INTEGRAL Bolting on the SAF BI-Series: Changeover to DELTAPROTEKT

SAF BI-Serie with DELTAPROTEKT-coated INTEGRAL-Bolting

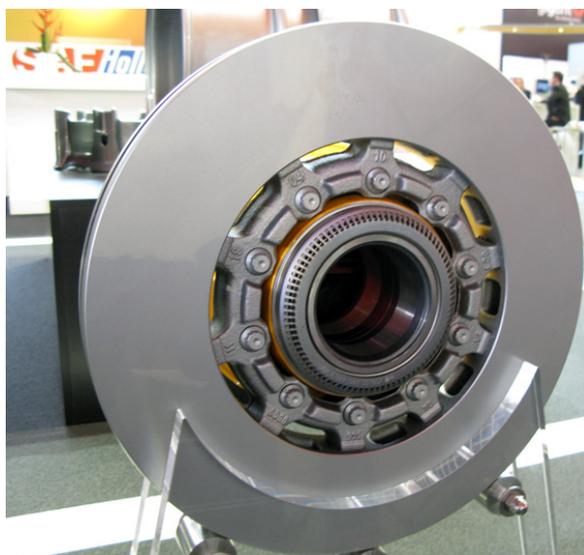
SAF-HOLLAND will, with immediate effect, convert to the Chrome VI-free DELTAPROTEKT coating on the INTEGRAL brake disc bolting for the **SAF BI-Series** in the course of continuing product optimisation.

The benefits of this new coating, apart from the Chrome VI-freedom, are the considerably improved corrosion protection of 504 hours salt spray resistance acc. to DIN 50 021 and the good temperature stability.

The new coating on bolts **04 375 1005 12** can be identified by the high quality silver colour (up until now matt black).

The former tightening process for the brake disc fixing of the **SAF BI-Series** with the new DELTAPROTEKT coating remains the same: Pretighten to **30 Nm** diagonally and then tighten by a further **90° diagonally** (check torque: 130 Nm). The identification number **04 375 1005 12** for the bolt size M12x1.5x75 remains the same.

Please note that when changing the brake discs the bolts **04 375 1005 12** must still be replaced. Bolts which have already been used **may not be used** again!
